APPLICANT: CAMFORD PROPERTY GROUP, INC 37 EAST CENTRAL STREET FRANKLIN, MASSACHUSETTS COVER SHEET PANTHER WAY FRANKLIN, MASSACHUSETTS PREPARED FOR CAMFORD PROPERTY GROUP, INC. 37 EAST CENTRAL STREET FRANKLIN, MASSACHUSETTS FEBRUARY 19, 2020 SCALE: 1" = 100'

Re: Panther Way Site Plan and Special Permit Application Peer Review

On behalf of the applicant Camford Property Group, Inc. we have provided responses to the following comments from the Franklin Town Engineer, Franklin Town Planner, Franklin Fire Department and BETA Group, Inc. The review comments are listed below and our response are immediately following each comment and have been italicized.

Re: Panther Way Site Plan and Special Permit Application Peer Review

EROSION CONTROL PLAN

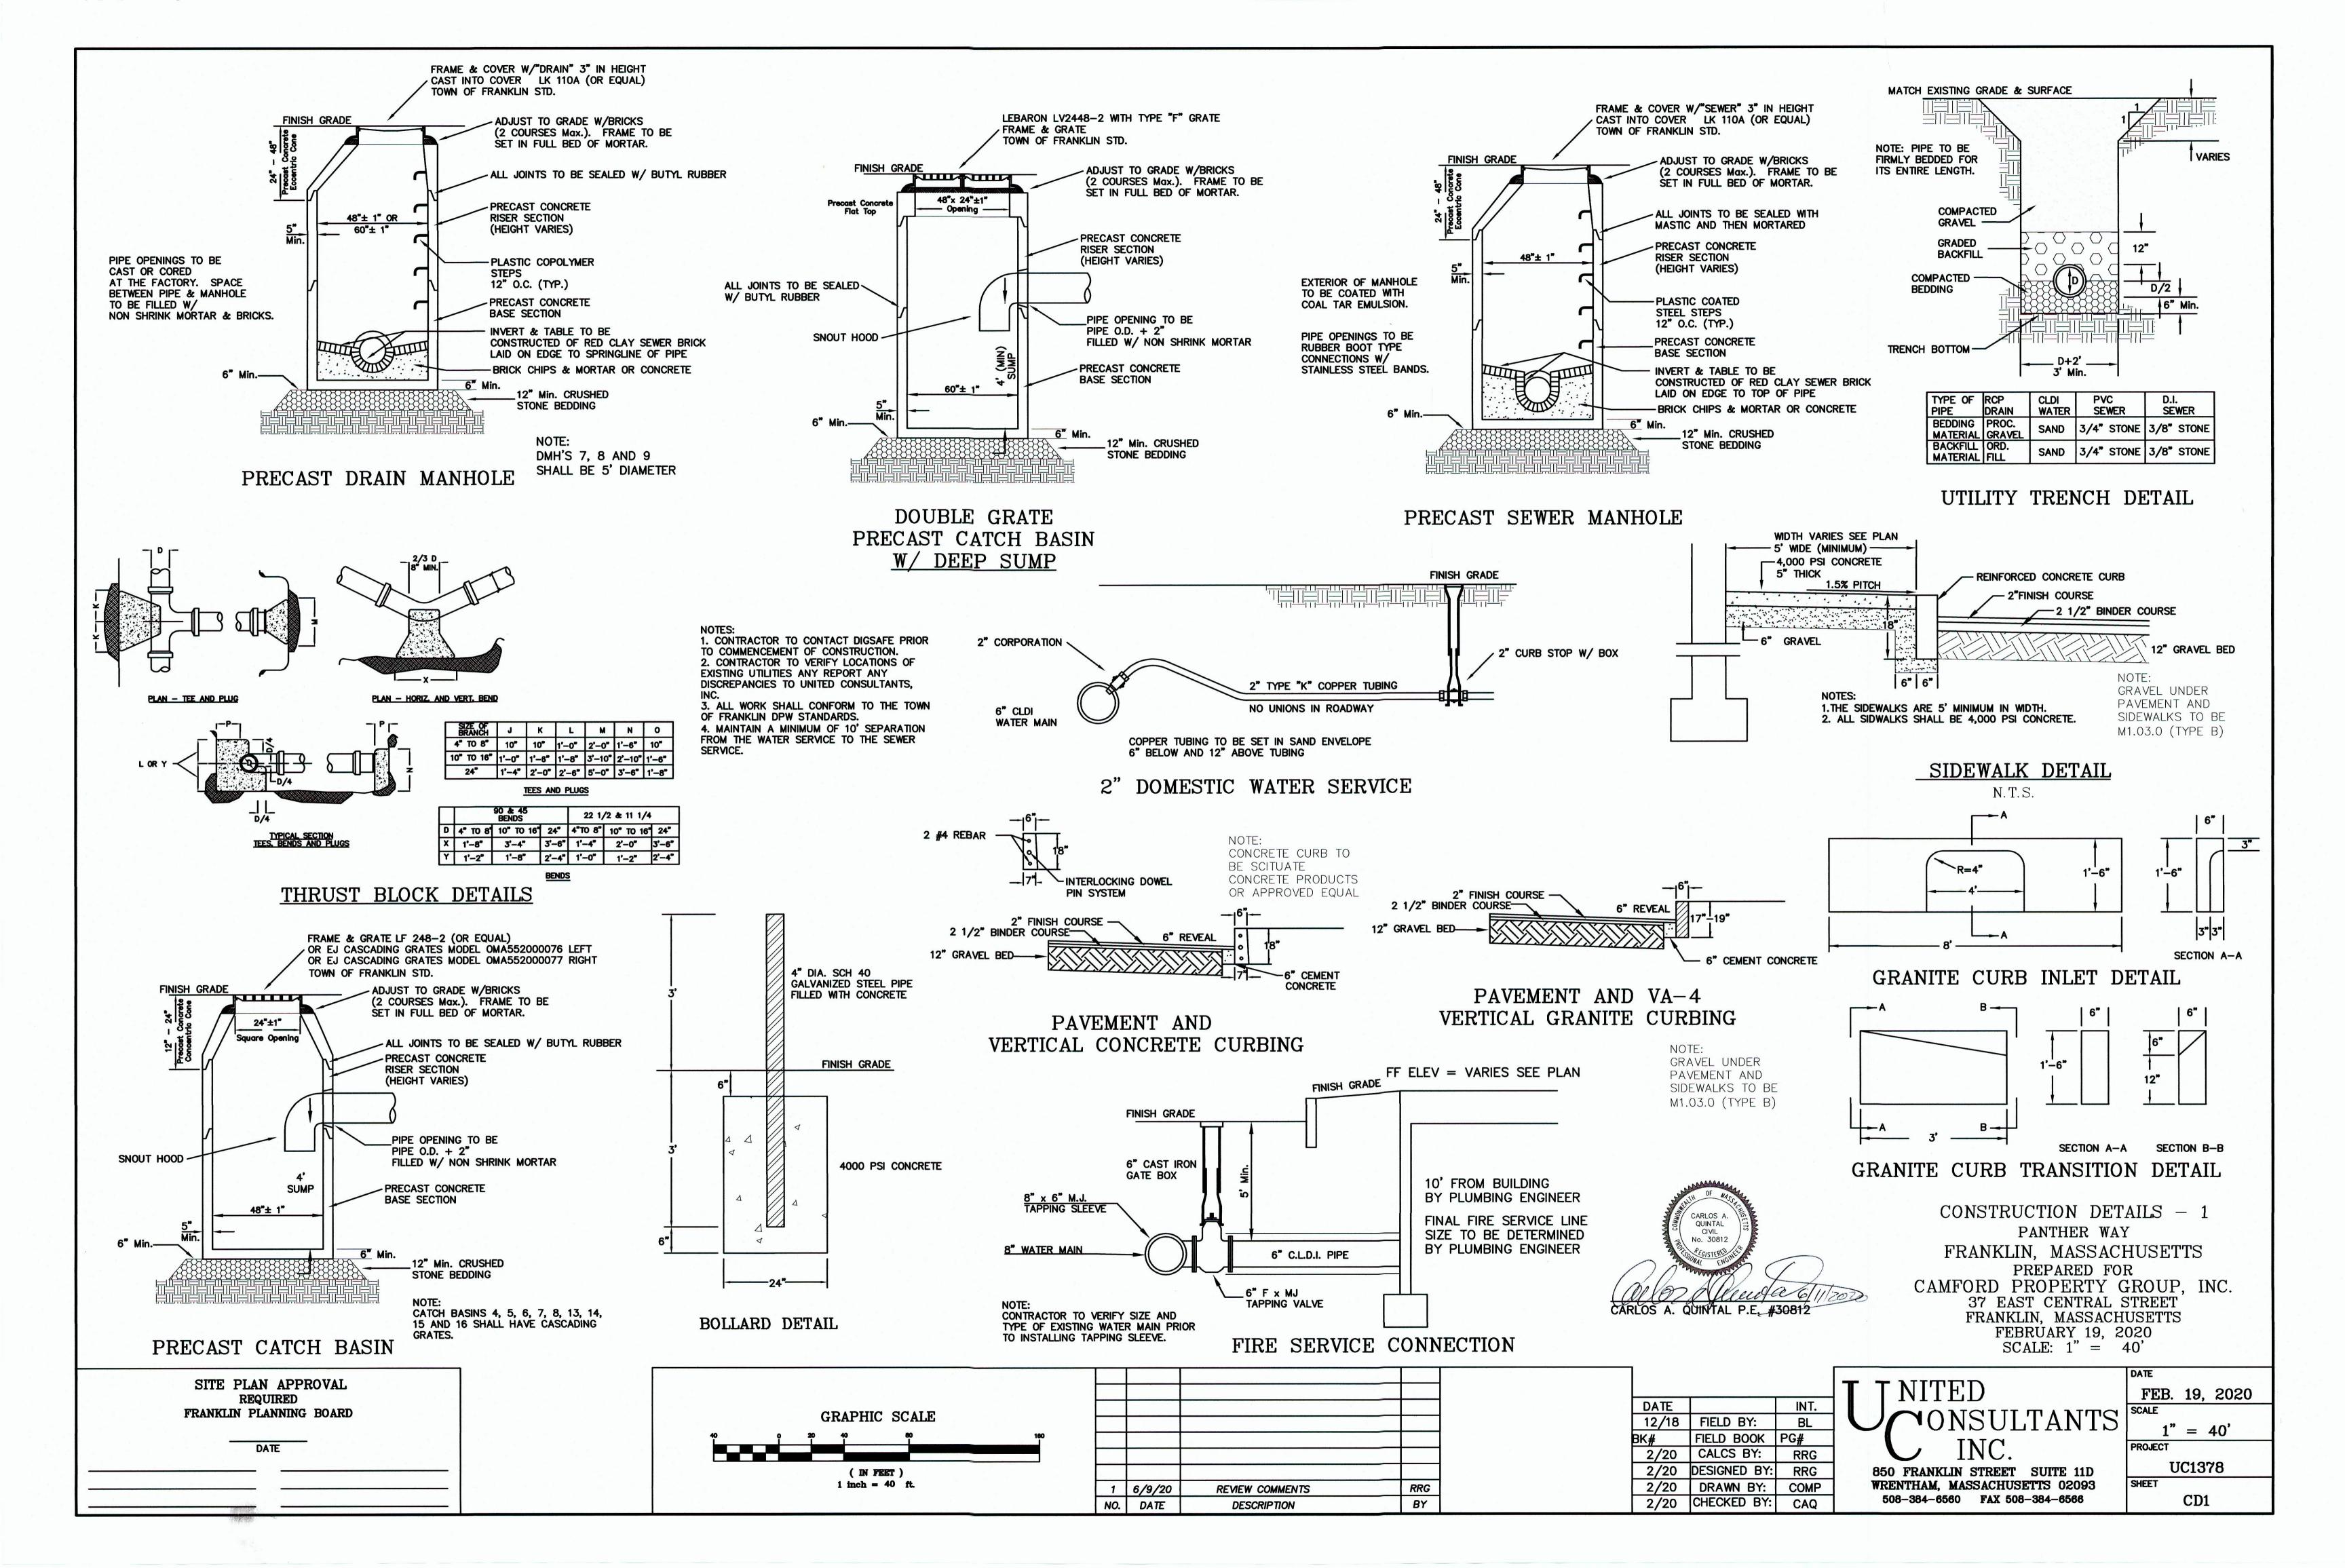
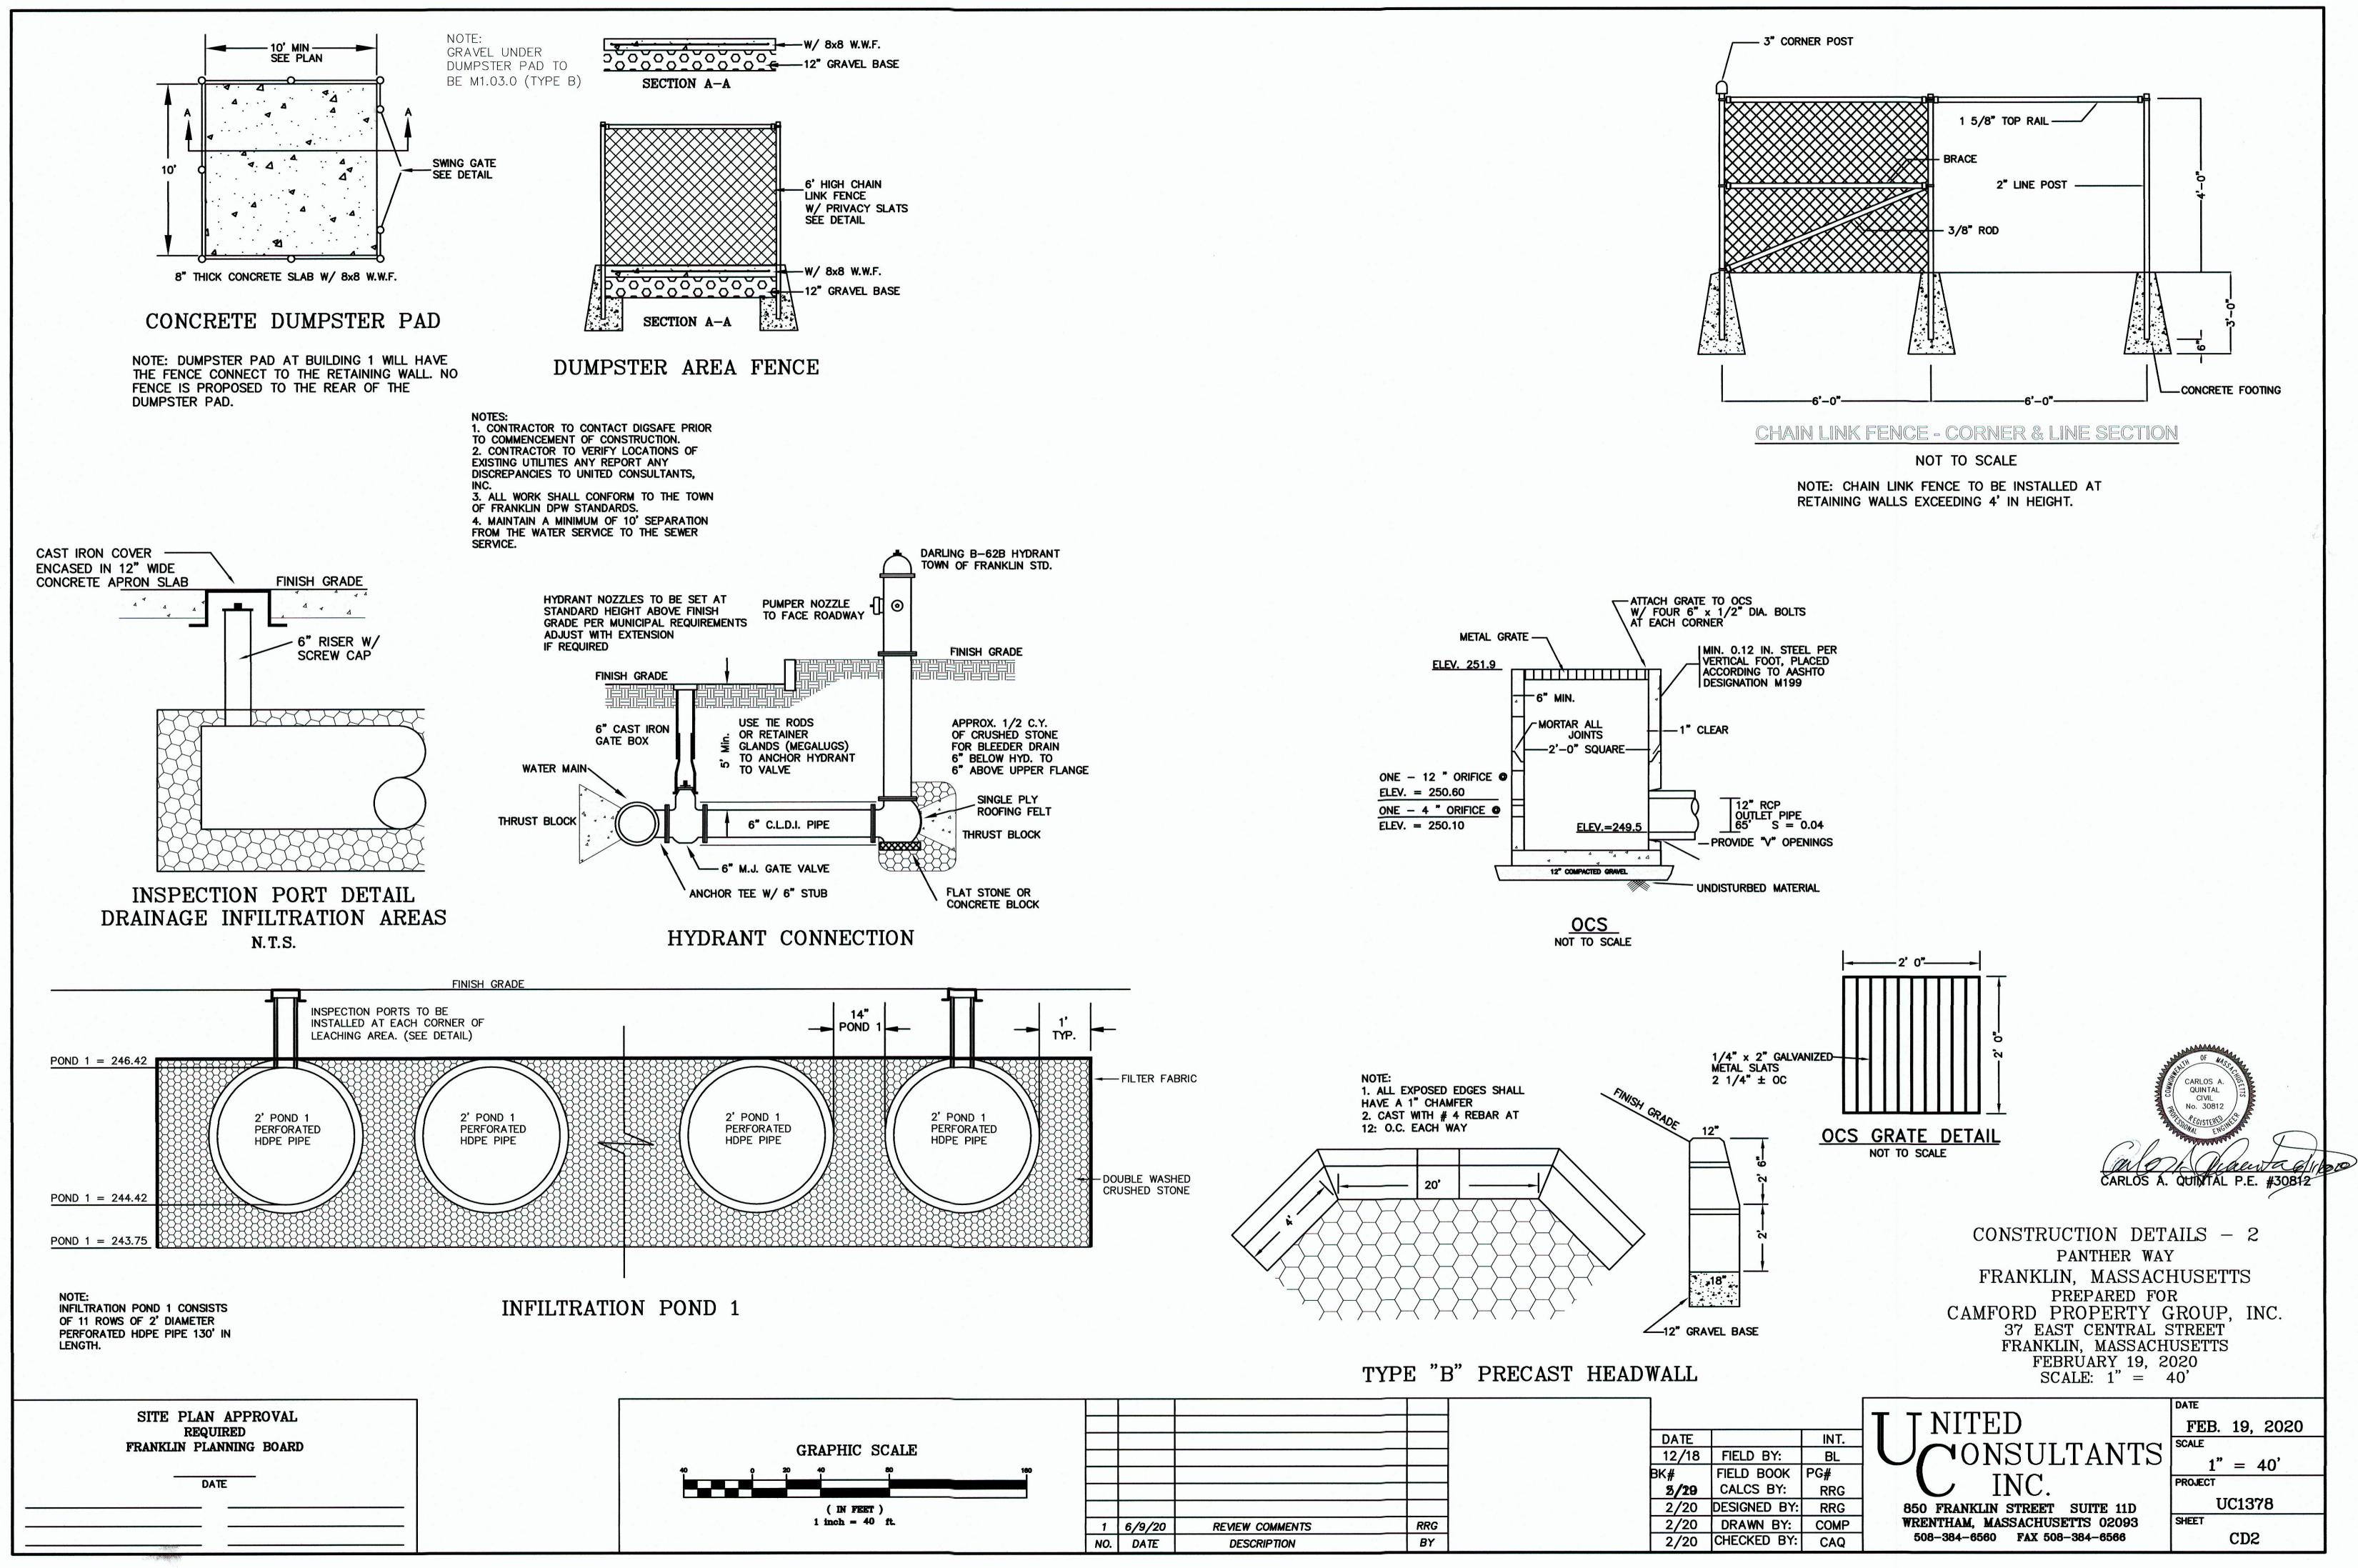
- **3.** The Erosion Control Plan indicates that slopes steeper than 3:1 shall be stabilized with hydroseed, geotextile fabric, or riprap as required. We recommend that slopes *equal to or* greater than 3:1 be stabilized as noted. *The note has been revised on sheet ERC1.*

SW9. Clarify the erosion control line/limit of work. It is clearly depicted at the northeast corner of the site; however, the end of the erosion control line is not readily visible.

SW10. Clarify construction sequence notes on sheet ERC1. There are two separate sets of notes.

The erosion control line has been made wider on sheet ERC-1. Additional labels were added to each end of the limit of work line on sheet PP1.

The notes have been revised.
